SPRING HILL PLANNING COMMISSION
REGULAR MEETING AGENDA

SPRING HILL PLANNING COMMISSION
SITE PLAN STAFF REPORT

Case #: SP-05-08 **Meeting Date:** November 6, 2008

Description: Proposed Site Plan, US Post Office

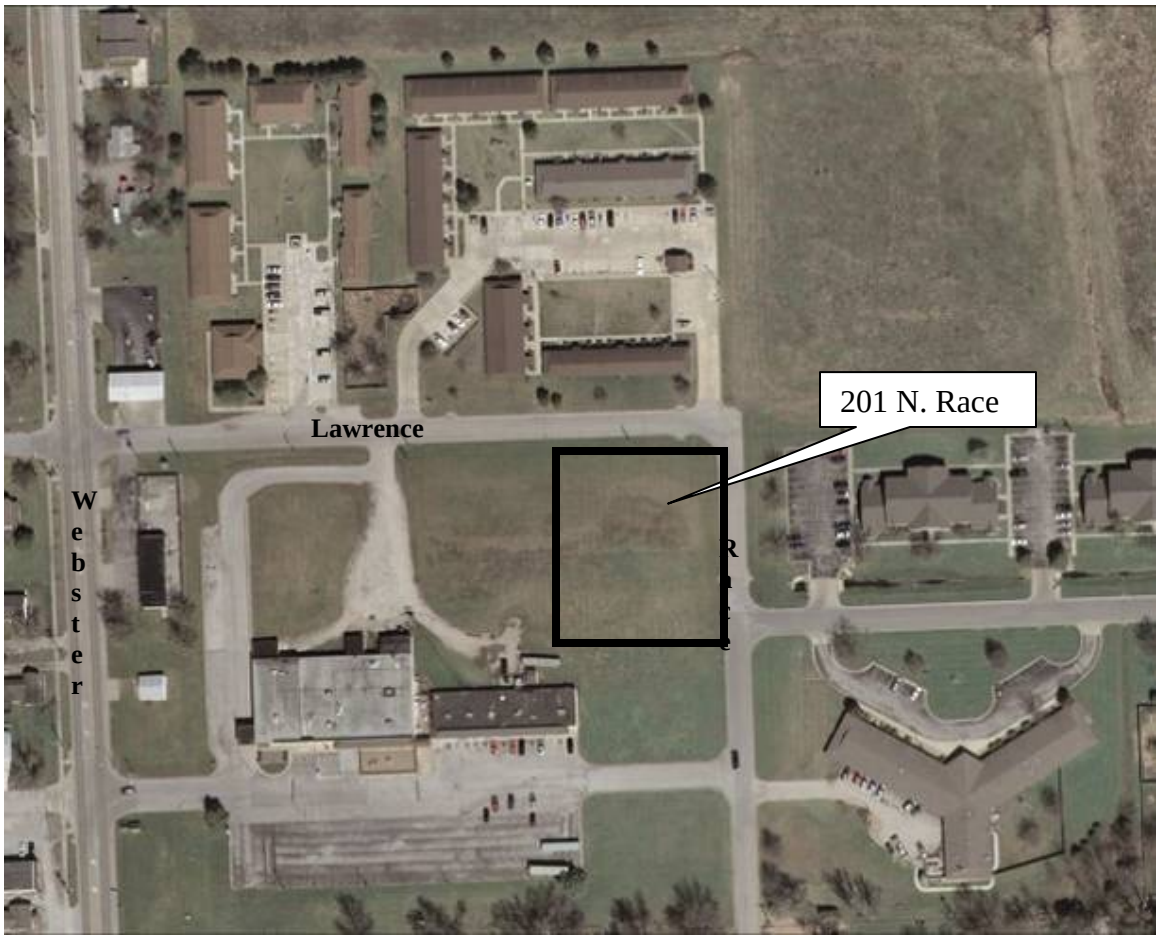
"I have started the review of the site plans for the new post office and it appears that we may have a serious problem. The new post office is to be located on property where we have planned new storm sewer improvements as part of Phase 3 of the Wilson Street SMAC project. At this point we have a design for Phase 3 that has been approved by the county but we have not acquired any easements. This project is scheduled to be constructed in 2010 with easement acquisition to start in mid 2009."

Because of this conflict with future storm water projects, Mr. Brann and I will meet with the design team prior to the Planning Commission and make a full report on Nov. 6 to the Planning Commission.

A1.1 ARCHITECTURAL FLOOR PLANS

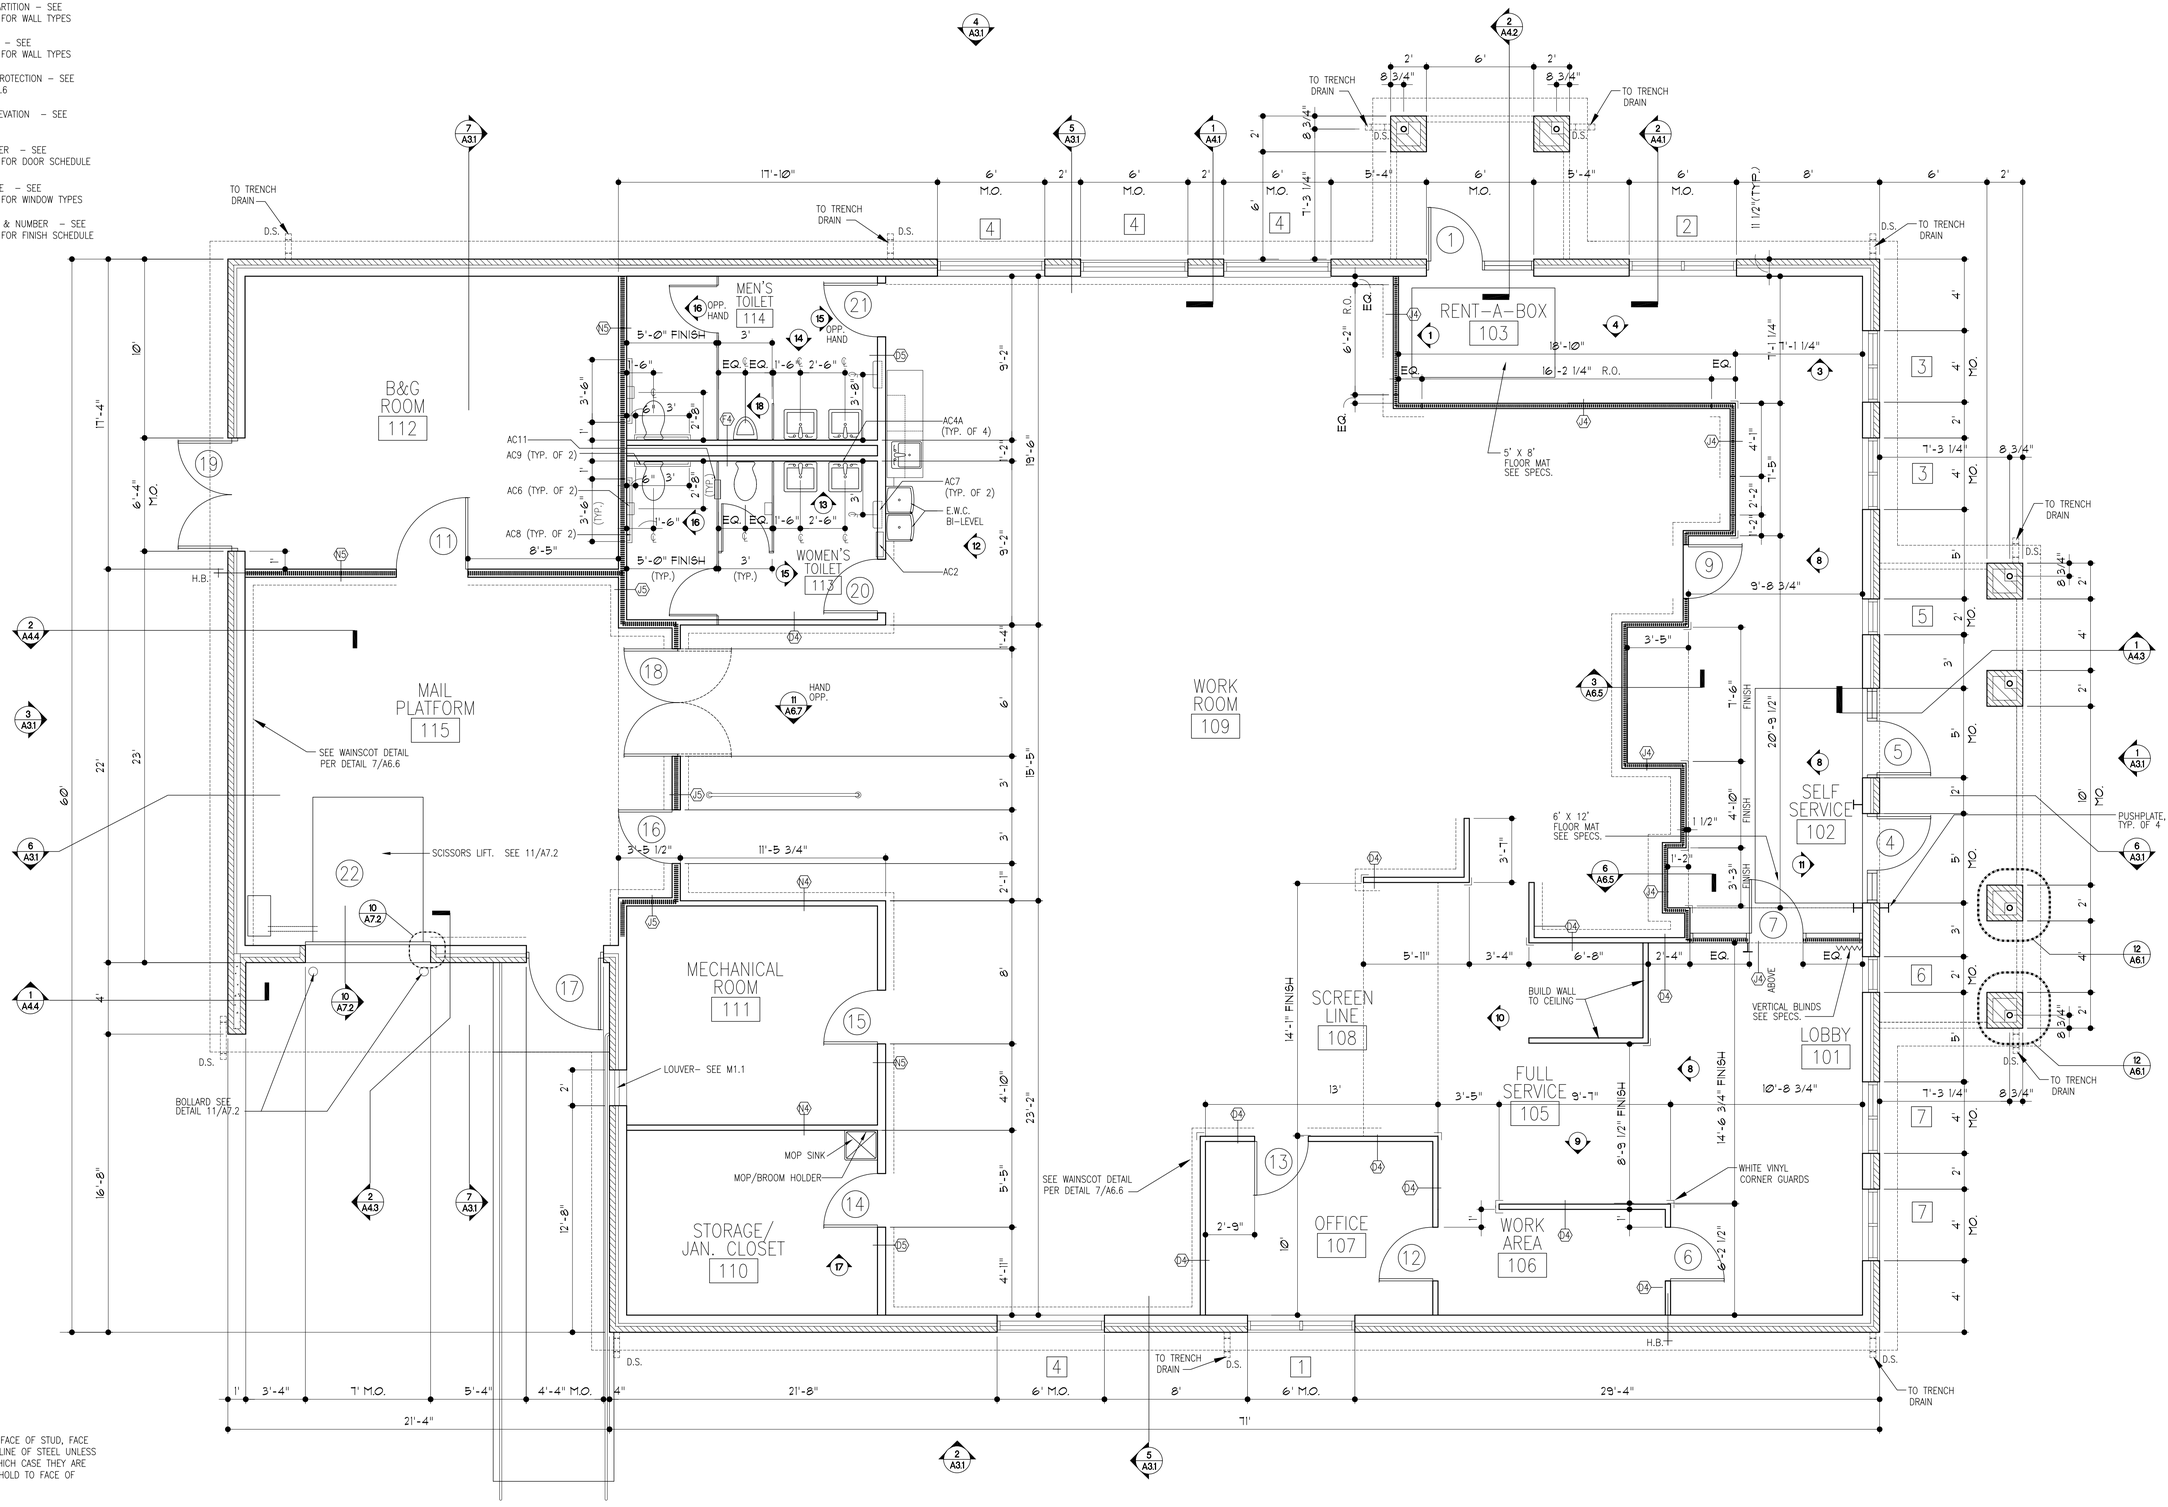
1. The method of screening for all ground and building mounted mechanical equipment ("condensing units") and meters (gas, electric, etc) needs to be identified. If landscaping cannot be provided around these elements, then an appropriate screen wall or other screening device compatible with the building exterior / materials should be provided. Painting the equipment is not considered an acceptable method of screening
